ARCHITECTURAL REVIEW BOARD STAFF REPORT

Project #/Name	ARB-2023-114: Flow Kia
Review Type	Preliminary Architectural Review
Parcel Identification	07800-00-00-009A0 and 07800-00-00-011B1
Location	1390 Richmond Road (Fig. 1)
Zoned	Highway Commercial (HC) / Entrance Corridor (EC)
Owner/Applicant	Flow 1390 Richmond LLC / Design Develop, LLC (Kevin Schafer)
Magisterial District	Rivanna
Proposal	To demolish and replace the southern portion, and renovate the northern portion, of the Kia auto dealership building.
Context	The subject parcel is on the north side of the Rt. 250 East EC, a corridor that is home to several other auto dealerships. The Kia building is the last remnant of popular mid-century roadside architecture that once predominated along this street.
Visibility	The proposed building will be readily visible from the EC street.
ARB Meeting Date	February 19, 2024
Staff Contact	Margaret Maliszewski

Fig. 1: Project location (left) and proposed areas of demolition, replacement, and renovation (right).

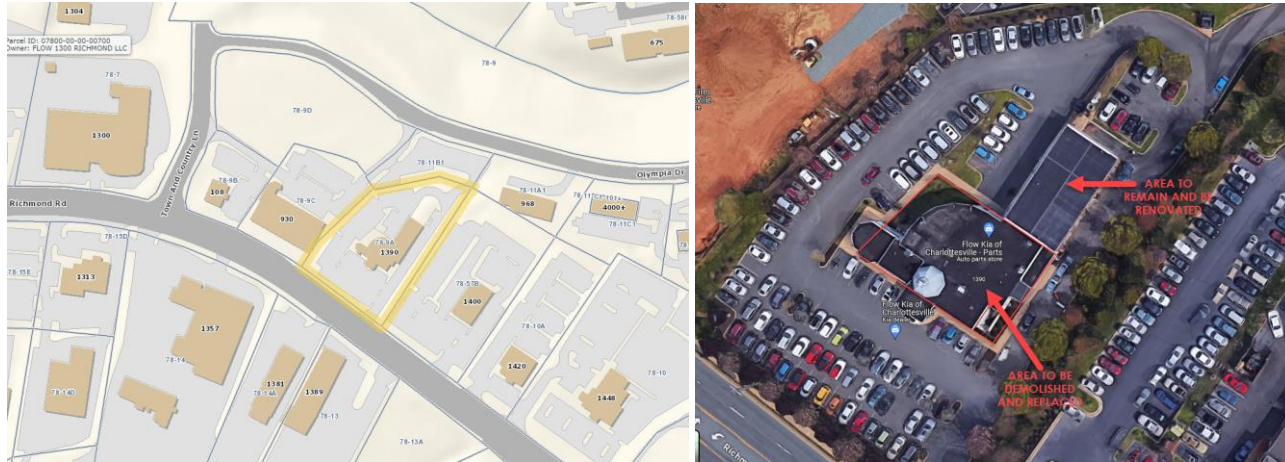
1. Possible revisions to ground the building, acknowledge vertical supports, establish rhythm, and/or reduce reflectivity.
2. The reflectivity of proposed building materials.

1. Provide samples of the black and silver ACM and the Coventry Gray paint for review.
2. Revise the architectural design to ground the building, acknowledge vertical supports, establish rhythm, and/or reduce reflectivity.

3. Provide the specifications on the window glass to confirm conformity with the guidelines requirements.
4. Show mechanical equipment locations and heights on the roof plan and building elevations.
